Beauly to Blackhillock to New Deer to Peterhead 400kV Overhead Line

Summary Report on Consultation

January 2025

Alignment Section 1: Fanellan substation to River Beauly at Cruives

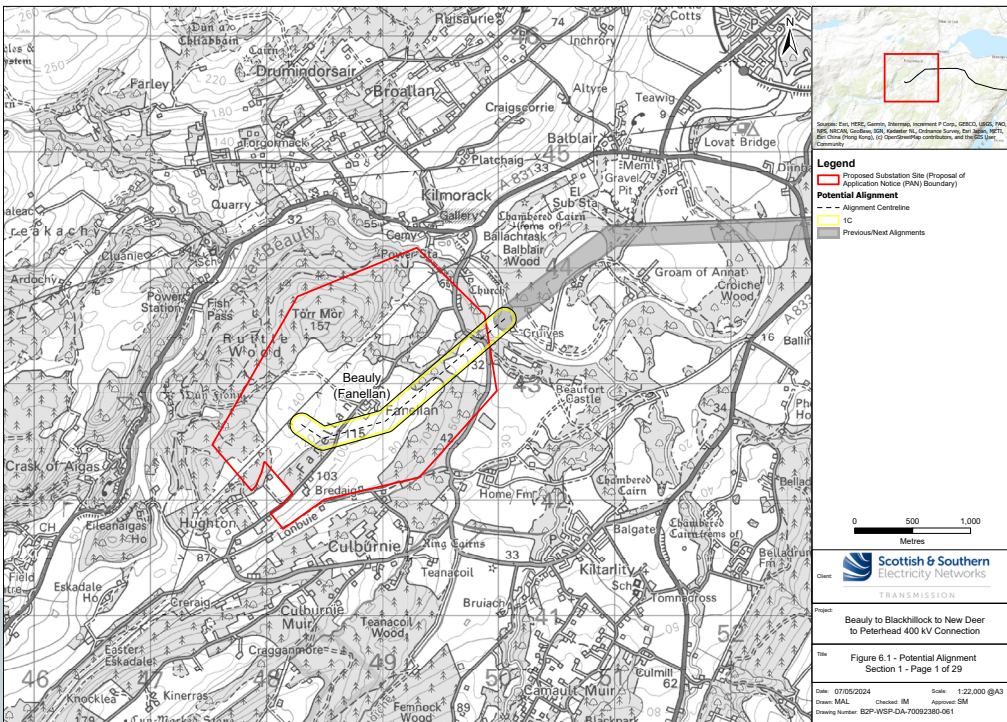
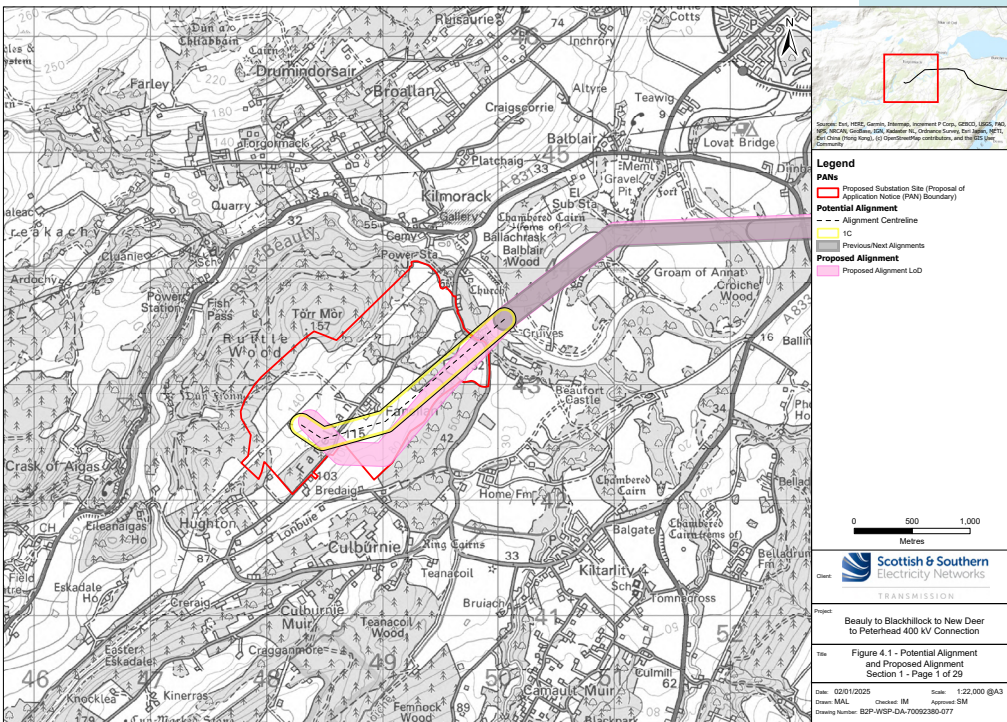
Within Alignment Sections 1 and 2 concerns were raised about construction traffic disturbance in the Beauly area, potential for land damage during construction, and potential impacts to protected birds and other species in woodland areas.

A request was received to keep the alignment close to field boundaries to minimise sterilisation of arable land.

Following further assessment, the Proposed Alignment has been refined slightly in Section 1 to keep closer to field boundaries.

Potential Alignment 1C has been refined at the southern end to reduce the impact on farm land. This change also sits at a lower elevation in the landscape, thus reducing landscape and visual effects.

Alignment Section 2: River Beauly at Cruives to River Beauly at Croiche Wood

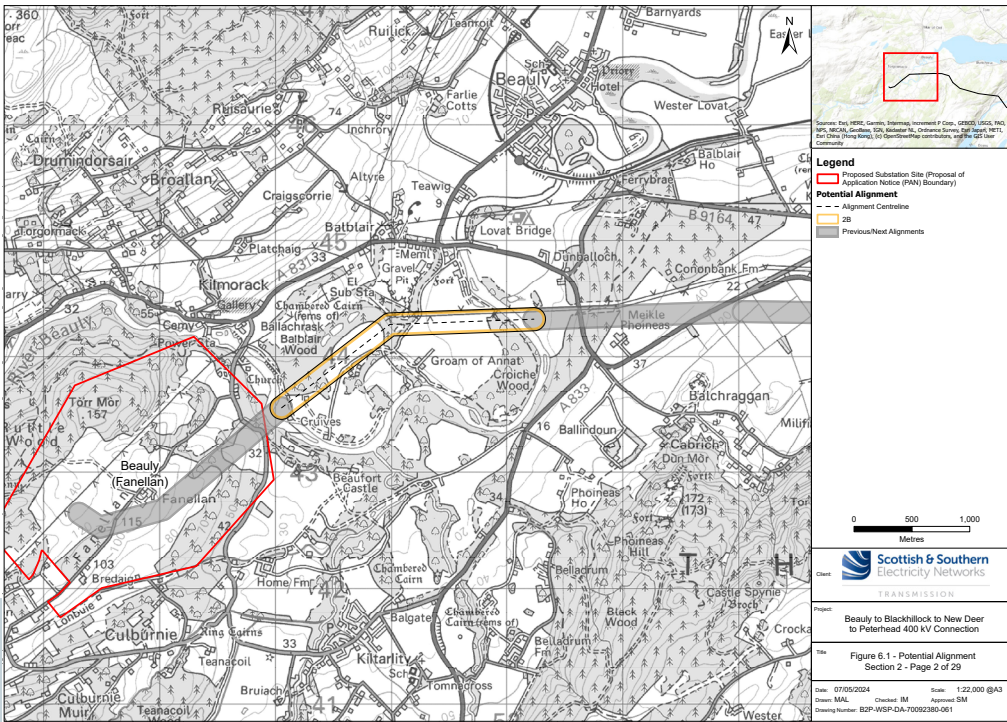
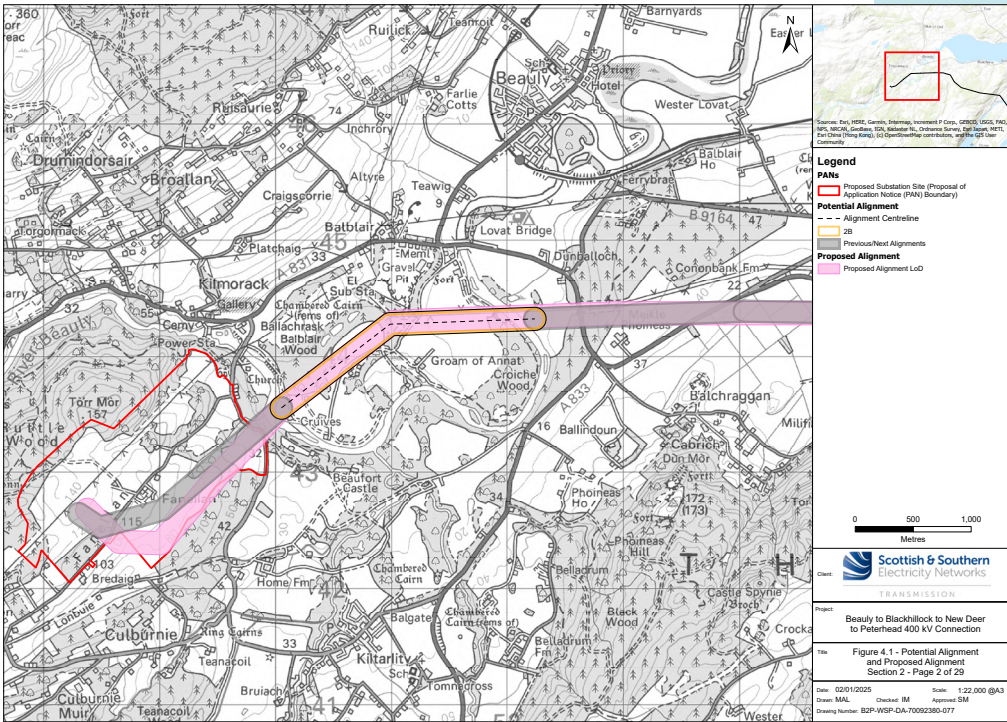
A suggestion was made for consideration of an alternative alignment to follow the route of the existing Beauly to Denny 400kV OHL to the south of Beauly substation, and also to follow the existing OHLs to the east of Beauly substation, which could reduce the environmental impact and overall length of the route.

However, in Section 2 the Potential Alignment runs parallel immediately to the south of the existing OHLs heading east from Beauly substation. The existing 132kV OHL will be removed following completion of the Proposed Development, and we will align the new 400kV OHL as close to the existing OHLs as possible, whilst maintaining operational safety clearance distances. Following further review, we have been able to slightly refine the Potential Alignment in Section 2 to bring it even closer to the existing OHLs.

Potential Alignment 2B has been refined slightly at its eastern end to be as close to the existing OHLs as possible.

Alignment Section 7: Black Wood of Leys to Meall Mor

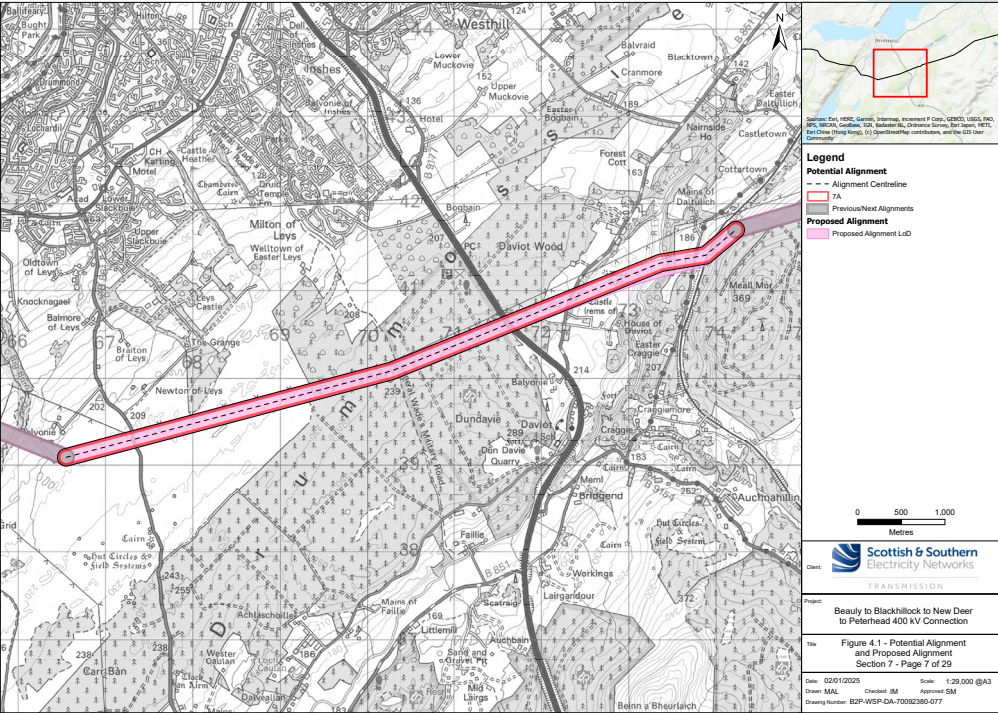
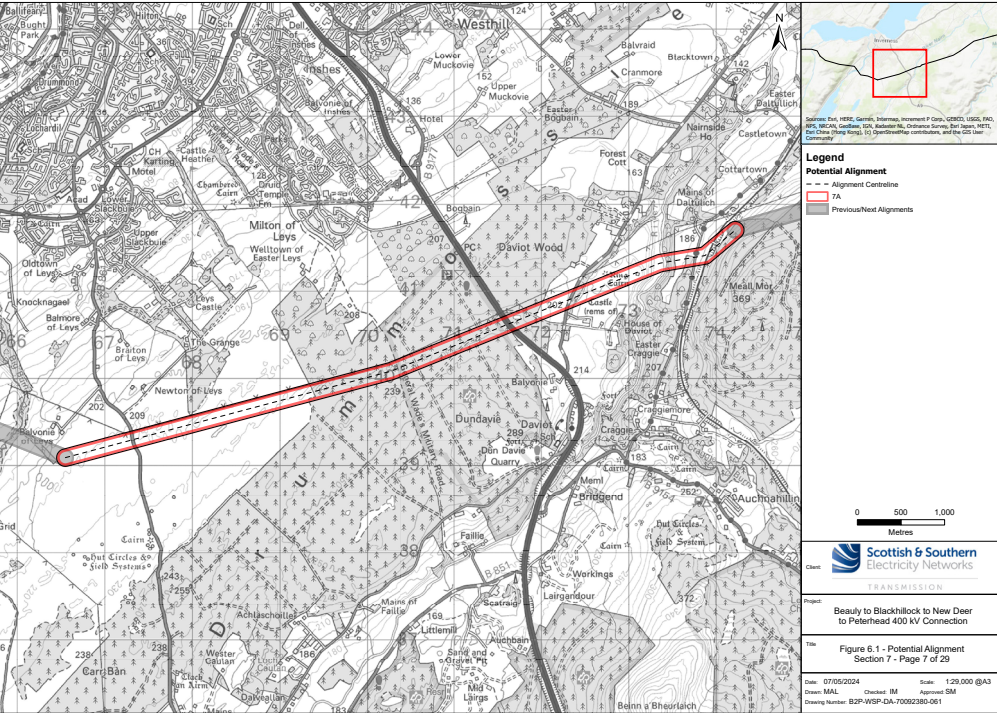
Within Alignment Section 7 concerns were raised about potential visual impacts of towers positioned in the vicinity of the A9 crossing point, potential impacts to the setting of Scheduled Monuments (including Daviot Cottage, Mains of Daviot Farm, ring cairn and stone circle and Daviot Castle), and potential impacts to Culloden Battlefield.

Potential for impacts on Culloden Battlefield is one of the primary concerns for us in developing an appropriate OHL alignment in this section. Therefore, the Proposed Alignment has been selected to minimise the impacts on the Culloden Battlefield site by running the new OHL in parallel to an existing OHL, with the new towers sitting behind the existing ones.

We will carefully consider tower positioning at the A9 crossing point at the design stage to minimise visual impacts to road users.

In the vicinity of the ring cairn and stone circle at Mains of Daviot, the alignment has been moved slightly further south to avoid the need to fell a small copse of trees to the east of the Scheduled Monument, in order to maintain some screening and break up the views at this location. The option of undergrounding a short section of the existing 275kV OHL is being considered by the design team to reduce the cumulative impacts to the ring cairn and stone circle.

Potential Alignment 7A has been refined slightly at its eastern end to reduce impacts to the ring cairn and stone circle Scheduled Monument.

Alignment Section 8: Meall Mor to Dalcharn

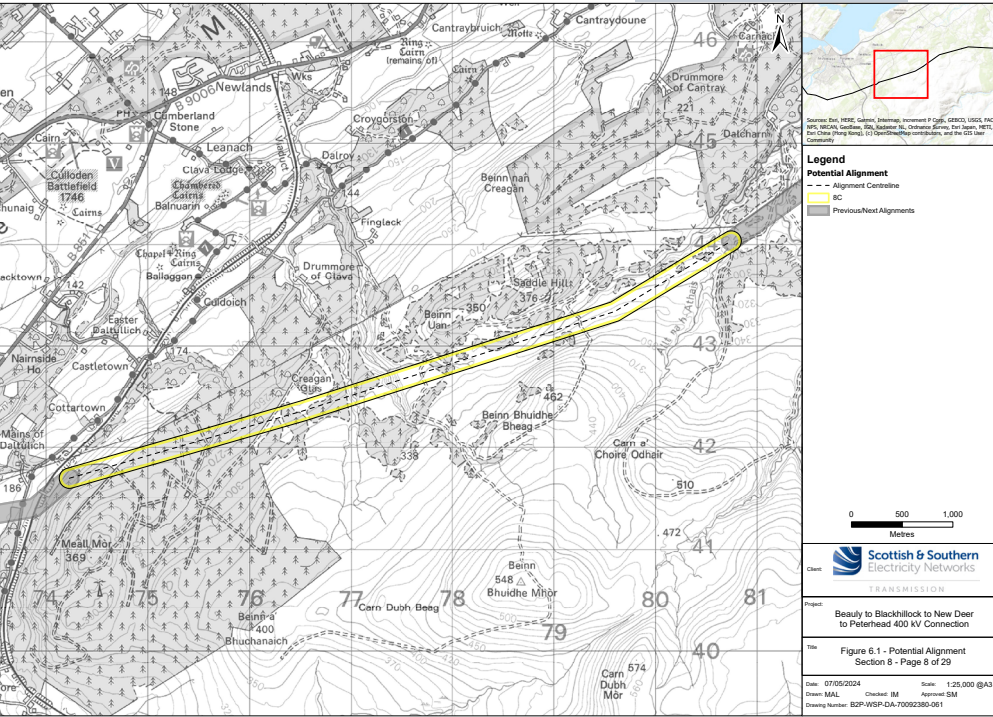
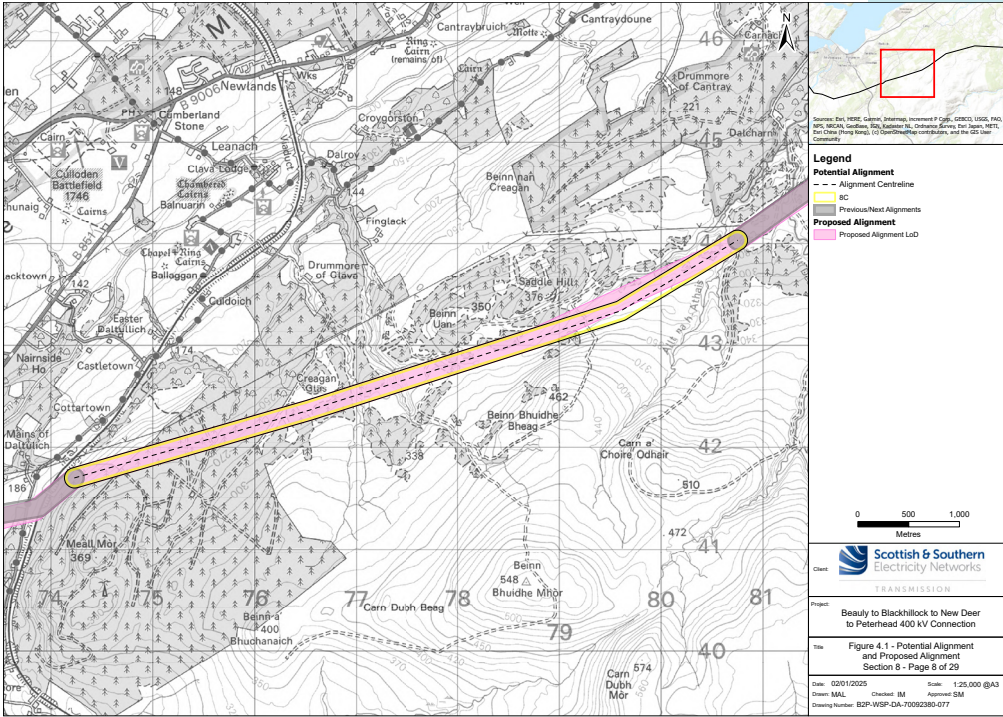
Concerns were raised about potential impacts to Culloden Battlefield, Culloden Muir Conservation Area, Clava Cairns Scheduled Monument and Dalroy and Clava Landforms SSSI, all in Alignment Section 8.

In Sections 8 and 9, requests were received to make some minor changes to the Potential Alignment to reduce impacts on estate activities and native woodland.

In Alignment Section 8 Culloden Battlefield, Culloden Muir Conservation Area and Clava Cairns Scheduled Monument were identified as cultural heritage constraints during the early stages of the route optioneering process, and the Proposed Alignment does not pass through any of these designated areas. The EIA Report will include a detailed cultural heritage assessment that will identify potential effects and their impact on heritage sites and assets, including those around Culloden.

The Proposed Alignment has been moved slightly north from the Potential Alignment (8C) to reduce impacts to existing estate activities. The Proposed Alignment sits on slightly lower ground, reducing the potential landscape and visual effects further, and also avoids some areas of deeper peat identified through peat probing surveys in this area.

Alignment Section 10: Clunas Reservoir to Newlands of Fleenas Wood

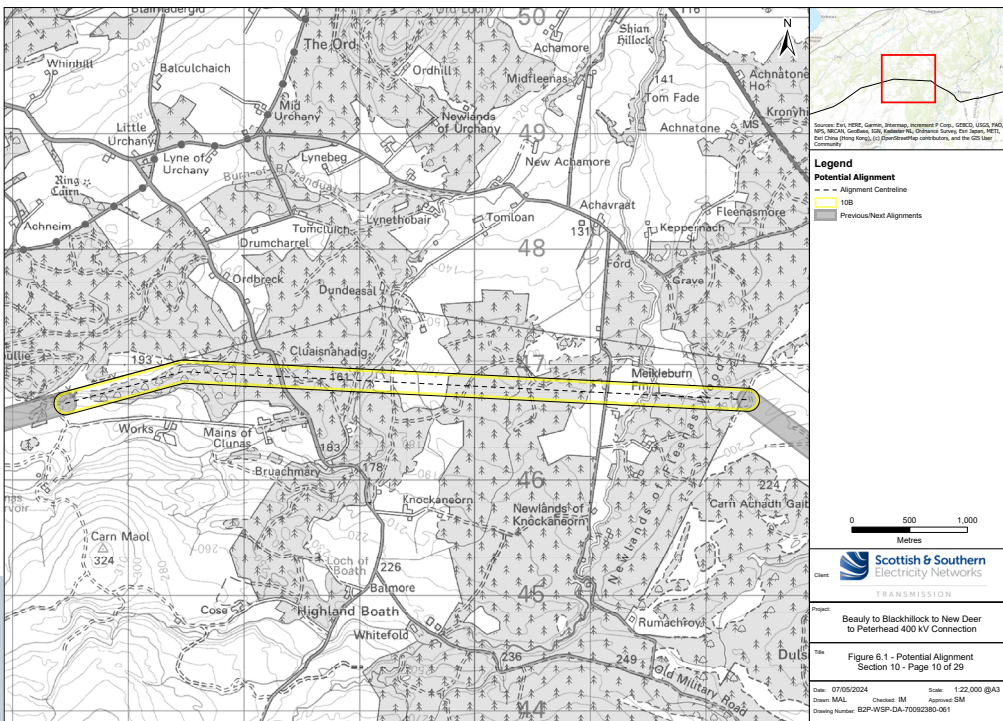
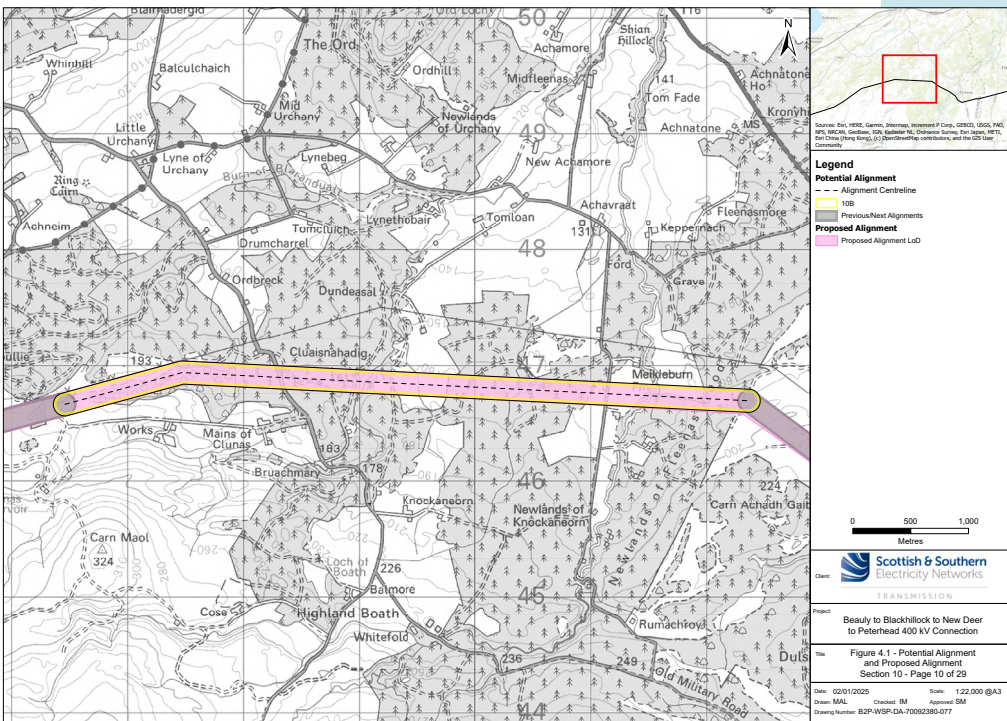
In Sections 10 and 11, concerns were raised about potential impacts to the capercaillie population of Darnaway and Lethan Forest Special Protection Area (SPA) due to potential for woodland habitat losses.

We are continuing to engage with NatureScot and RSPB throughout the EIA and design evolution process to identify mitigation measures to protect capercaillie populations.

Potential Alignment 10B has been refined at its eastern end due to a slight change in an angle tower position following engineering surveys, to increase the distance from a nearby watercourse.

Alignment Section 11: Newlands of Fleenas Wood to Cairn Duhie

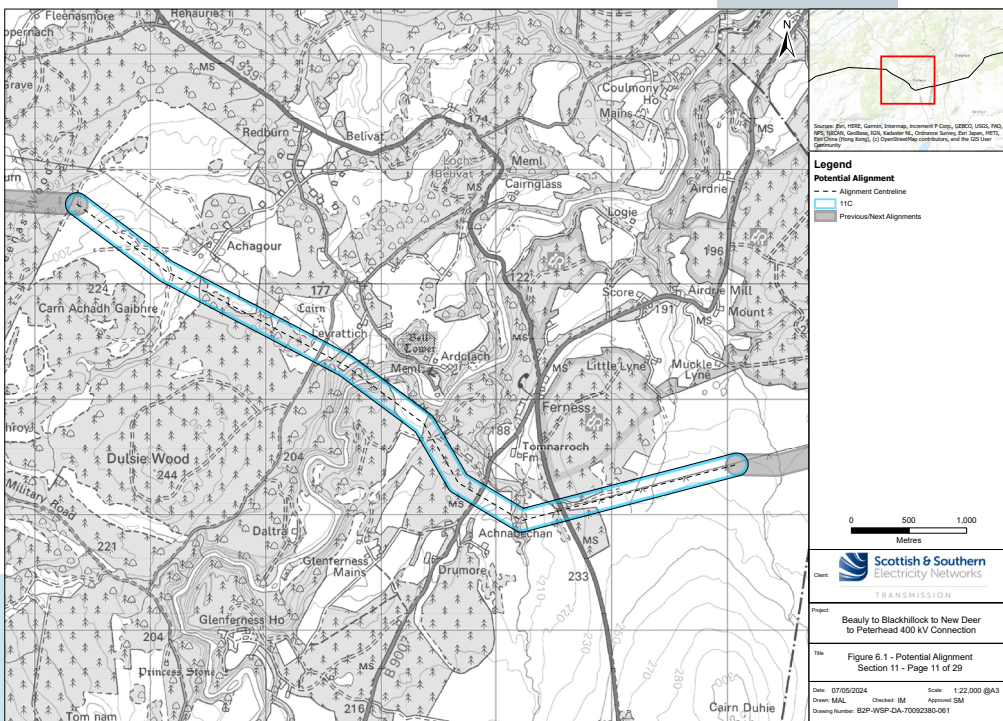
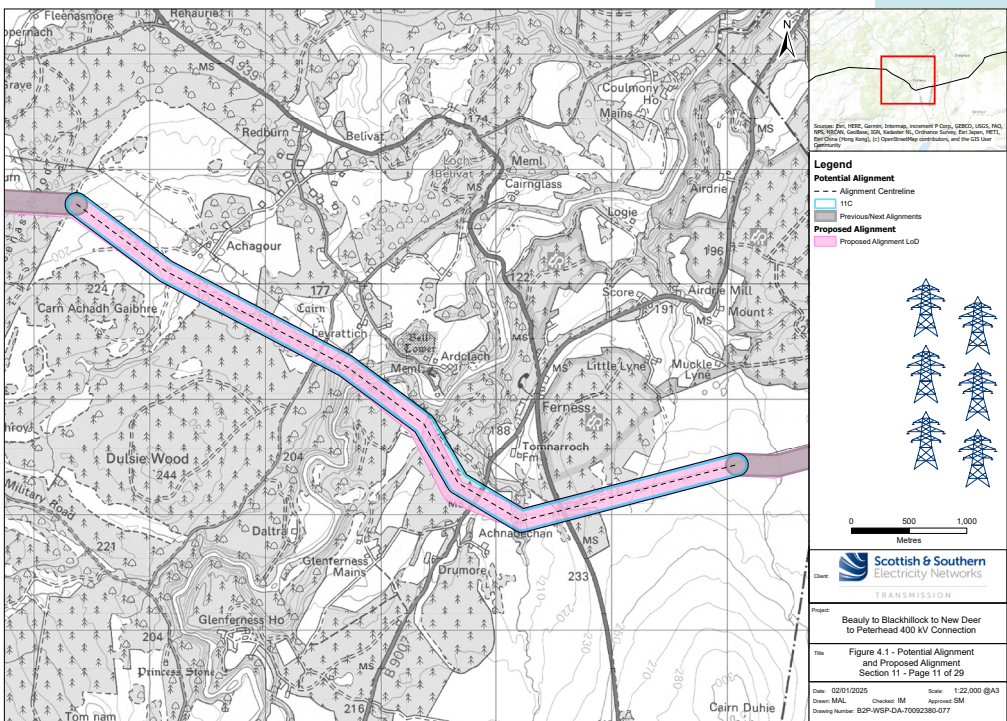
Concern was raised about cumulative visual impacts to the cliff walk near Ardclach Bell Tower, with a request for the more southern alignment option (11C) to be reconsidered.

A request was made to move an angle tower in Alignment Section 11 to increase the distance from residential properties.

We recognise the concerns raised about potential cumulative impacts of OHL infrastructure at Ardclach Bell Tower. From a wider landscape and visual perspective, and in terms of minimising heritage impacts on the Ardclach Bell Tower, keeping the two OHLs close together at the crossing of the River Findhorn was considered to be the least impactful option, reducing forestry loss and containing infrastructure within a smaller area.

Feedback was able to be accommodated to increase the distance from two properties in Section 11. The Proposed Alignment is equidistant between two properties.

Potential Alignment 11C has been slightly refined to the east of the River Findhorn to increase separation distance from residential properties.
